Item 11: Bearkat – North McCamey – Sand Lake 345-kV Transmission Line Addition RPG Project

Board of Directors Meeting

ERCOT Independent Review of the Bearkat – North McCamey – Sand Lake 345-kV Transmission Line Addition Project

Final

Figure 4.1 Additional Alternatives

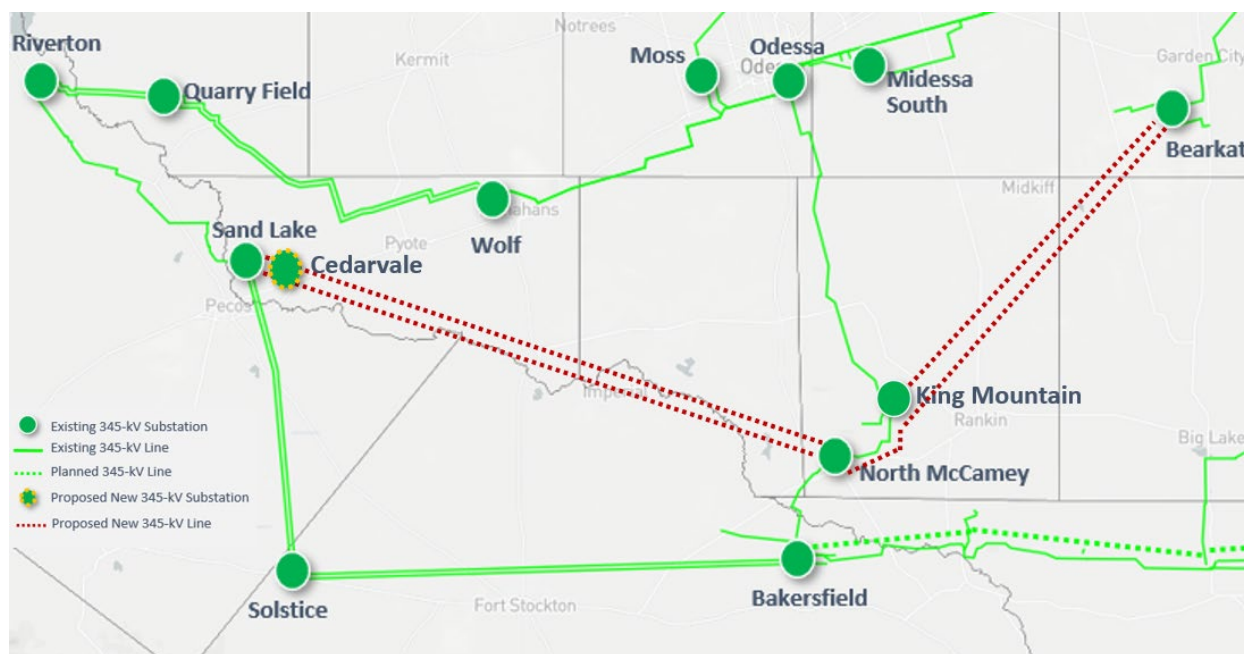
GP&L's alternative slightly modifies the Stage 2 upgrade by terminating one of the new 345-kV circuits from Bearkat at King Mountain and making portion of the new Bearkat – North McCamey circuit share the same towers with the existing King Mountain to North McCamey circuit as shown in Figure 4.1.

ERCOT evaluated GP&L's alternative and determined that the proposed Stage 2 upgrade is more reliable than GP&L's alternative based on the following reasons:

- The Stage 2 upgrade provides one more outlet to North McCamey where two 800 MVA 345/138 kV transformers are located to serve the load and generation on the 138-kV system in the McCamey area, compared to GP&L's alternative.

- GP&L's alternative will leave only one circuit from Bearkat to North McCamey under the maintenance outage of the existing North McCamey to King Mountain circuit. ERCOT's steady-state analysis with the maintenance outage condition showed thermal overloads on some of the 138-kV lines in the McCamey area.

- Under GP&L's alternative, a NERC Category P7 contingency will remove both the existing North McCamey – King Mountain 345-kV line and the new North McCamey – Bearkat 345-kV line. ERCOT conducted a high-level stability study for GP&L's alternative, and the study indicated negative impact on the McCamey GTC limit under the prior outage of Noelke – Schneeman Draw or Cedar Canyon – Noelke 345-kV double circuits when compared to the Stage 2 upgrade.

- Extended construction outages or higher energized construction costs may be needed to add a second 345-kV circuit on the existing towers in GP&L's alternative.

TNMP's alternative slightly modifies the Stage 2 upgrade by looping the new North McCamey to Sand Lake double-circuit 345-kV line into a new Cedarvale 345-kV substation (~ 3.7 miles southeast of the existing Sand Lake substation) in order to accommodate potential large flexible loads in the area. According to the response to the TNMP comment, Oncor and TNMP agreed that the LCRA TSC, Oncor, and WETT Bearkat – North McCamey – Sand Lake 345kV Transmission Line Addition Project should move forward without delay as originally submitted. The response from the TSPs also indicated that "both Oncor and TNMP will remain committed to effectively and efficiently address transmission system concerns that arise from the recent influx of customer loads in the Far West region beyond that which was identified in the scope of the original Delaware Basin area review."

Since such loads are currently under review by Large Flexible Load Task Force, ERCOT also recommends moving forward with the proposed Stage 2 upgrade.
